Waterloo Metro Quarter Basement Modification 1

Design modifications
State Significant Development Modification Assessment
(SSD 10438 MOD 1)

August 2022

Figure 4 | Proposed Basement Level 01 Plan

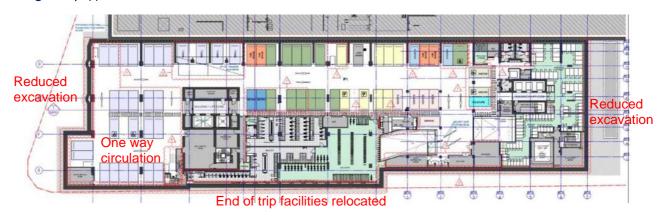
- reduction in the excavation footprint of the basement by 200 m² or 1400 m³ below Church Square and Raglan Street Plaza
- · reconfiguration of service areas
- relocation of end-of-trip facilities to better align with Northern Precinct and Central Precinct lift cores and accesses
- introduce one way circulation to northern aisles within the two-level car park
- consolidate residential parking to Basement 01 level and reconfigure the layout of the residential spaces
- adjustments to slab levels on ground level to reflect flood analysis requirements
- alter the footprint of the on-site detention tank to the south of the Central Precinct.

The Applicant states the proposed modifications are minor and typical of design refinement changes that occur during design development. The Applicant also says the rearrangement of the basement will be safer for users, the reduced excavation will increase deep soil landscaping within Church Square, and the floor levels are all above the probable maximum flood and 1% annual exceedance +500mm levels.

The Department also supports the proposed changes and considers them an improvement on the current design.
